**ADDENDUM NO. 2**

**MONTE VISTA ELEMENTARY SCHOOL  
INTERIM HOUSING PROJECT  
GLENDALE UNIFIED SCHOOL DISTRICT**

DSA Appl. No.03-121306  
DSA File No. 19-41

**RESPONSES TO PRE-BID RFI'S**

owner  
tBP project number : 21056.00  
file name:  
drawn by: checked by:  
date: MARCH 08, 2021  
Rev: date: description:  
4/22/2021 ADDENDUM #2  
drawing title:  
**GRADING PLAN**  
drawing no.:  
**C003**  
drawing of

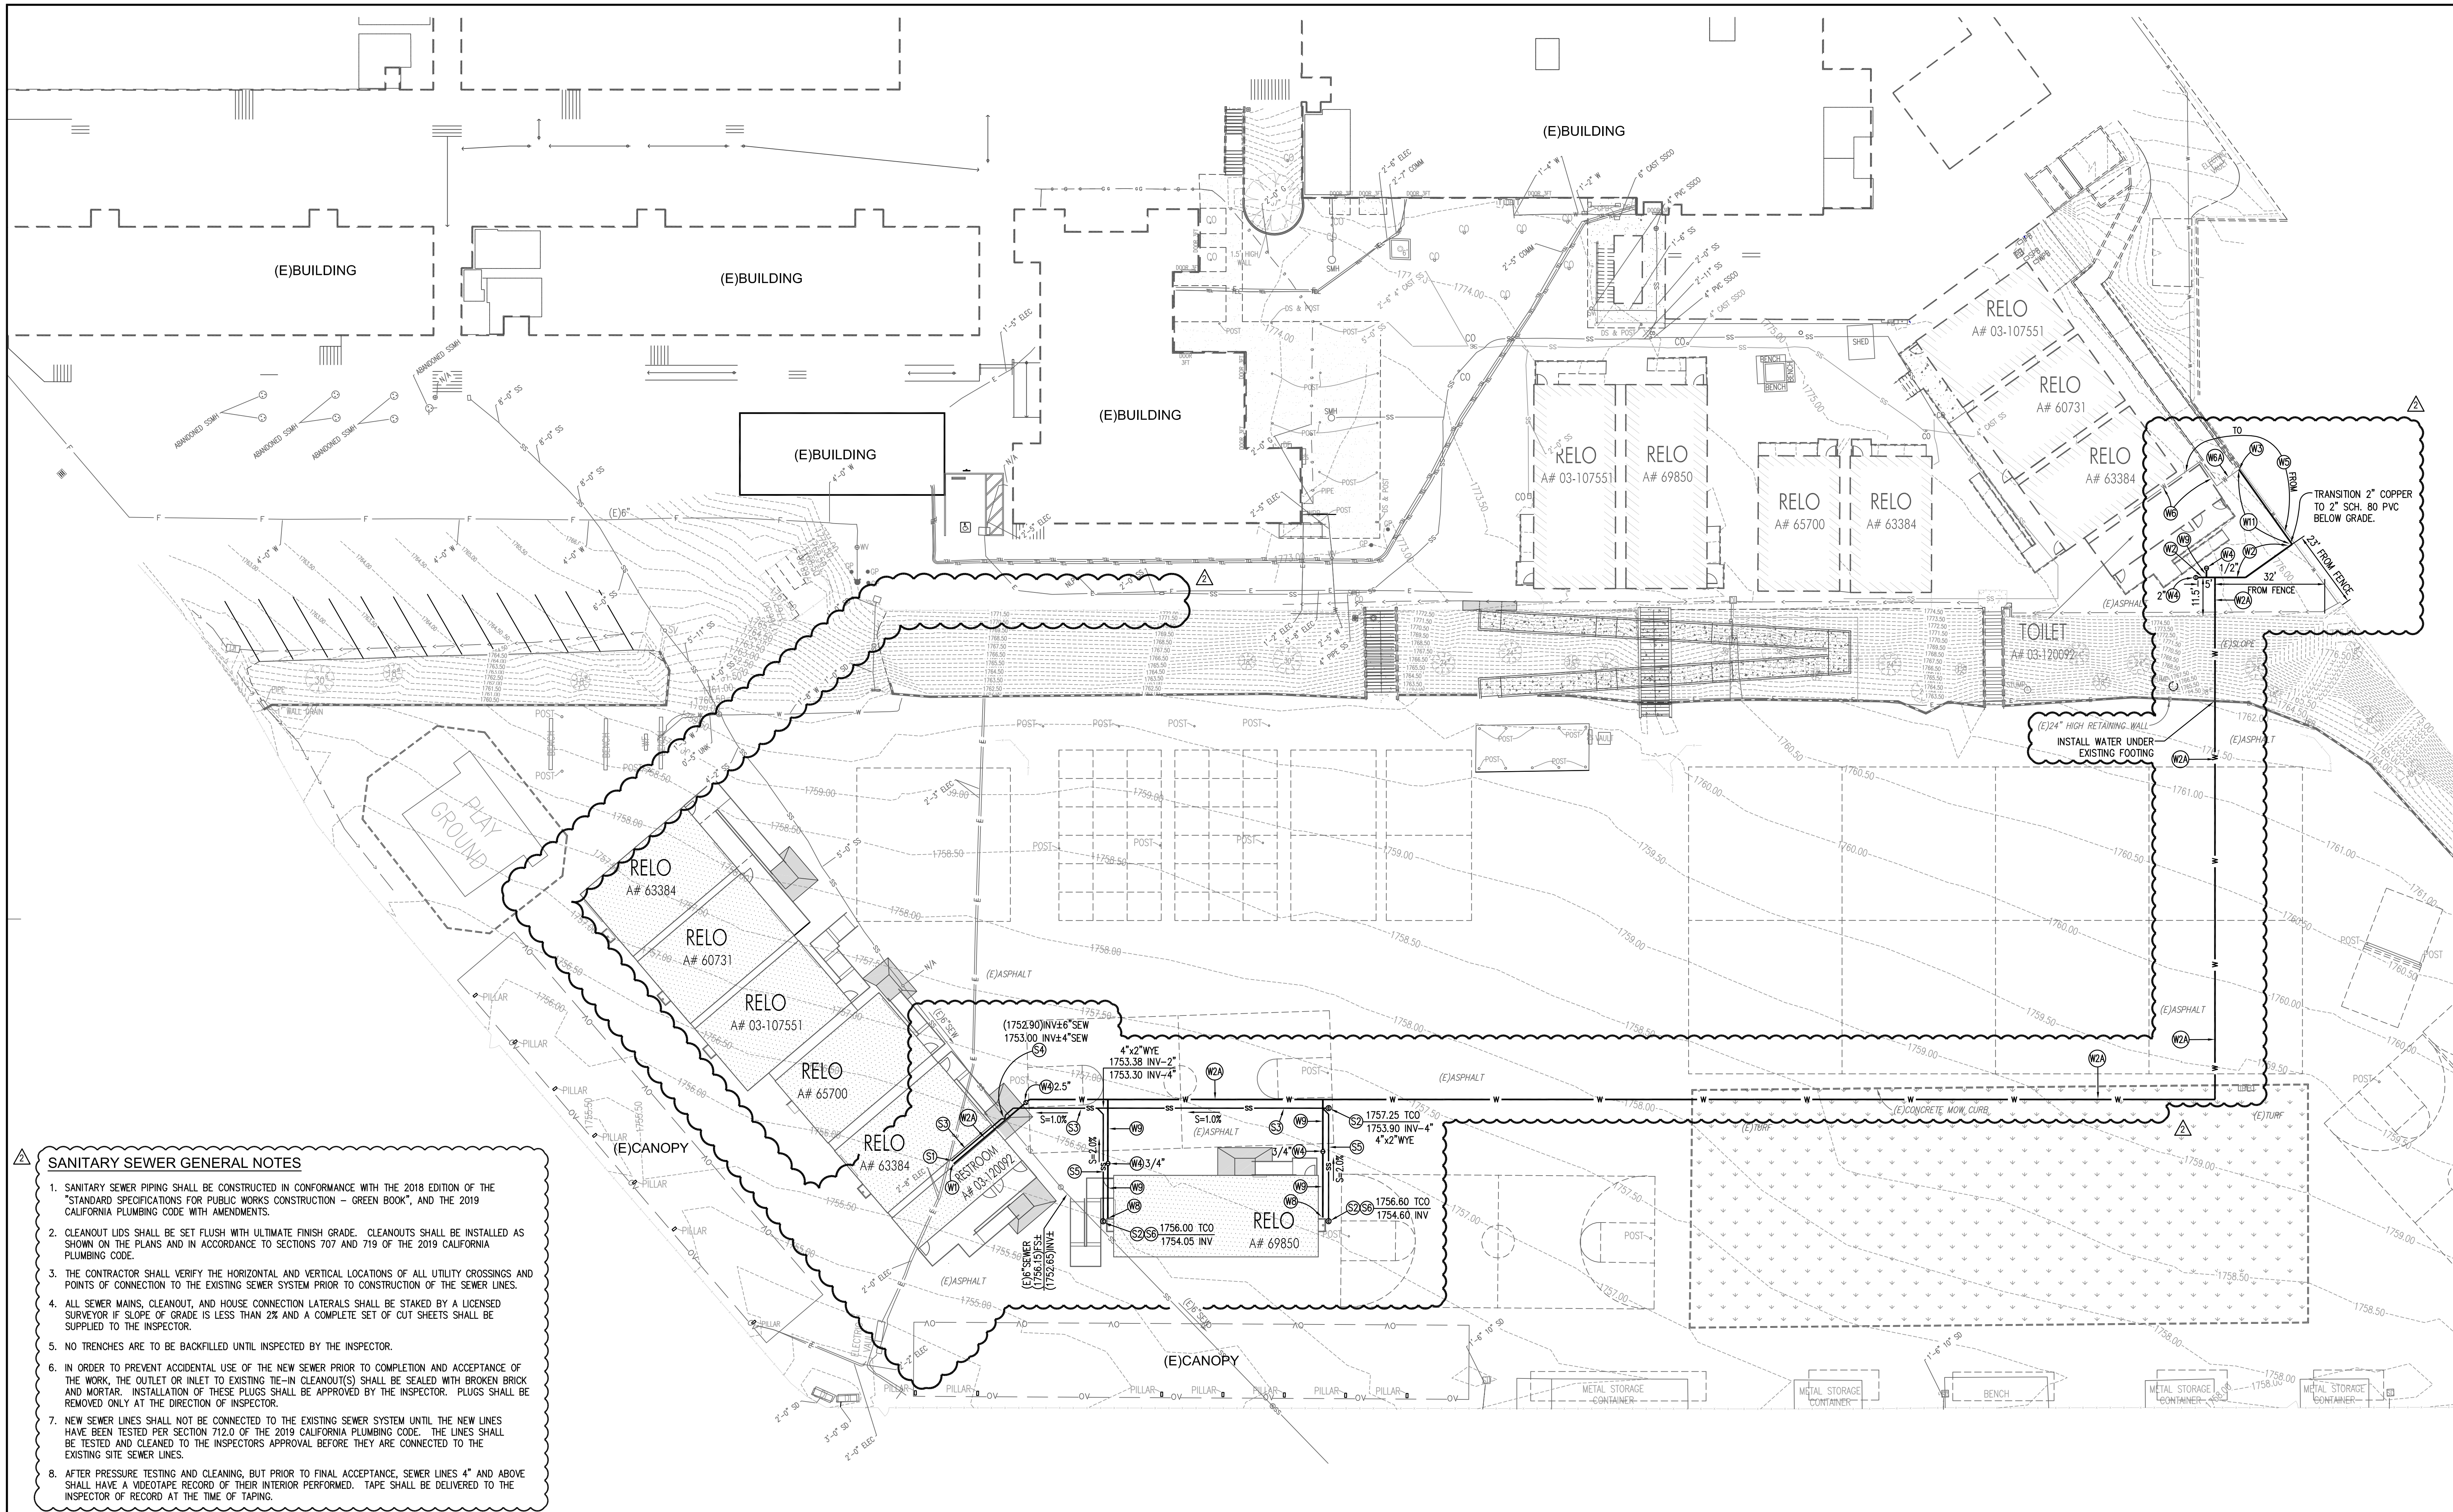
1. SHEET C004 – UTILITY PLAN  
Removed sanitary sewer ejector pump, updated keynotes, updated the potable water construction notes and added AC ramp transition notation.
2. SHEET C003 – GRADING PLAN  
Revised construction note No. 3.
3. SHEET C005 – DETAIL SHEET  
Revised detail for shut-off valve in yard box and added thrust block details.
4. SHEET AS-1 - OVERALL SITE PLAN  
Showing location of electrical trenching.
5. SHEET AS-5 - NEW CONCRETE RAMP  
Added splice and drainage requirements for retaining walls.
6. SHEET 2.01 – DETAILS  
Revise drywell detail 17/2.01.
7. SHEET E0-1 – SYMBOL LIST, GENERAL NOTES & DETAILS  
Revised grounding detail reference as shown on plans.
8. SHEET E0-2 – SINGLE LINE DIAGRAM
  - a. Deleted the feed to sewage ejector pump in Distribution Switchboard “DBR2”

24. Reference Sheet C003

Note 3 on C003 states to construct retaining wall per structural details.

Please provide structural CMU details.

Please confirm scope of CMU is limited to the 9' 8" closure at demolished concrete stairway.

**Response** – Notes and details updated in Addendum No. 2.
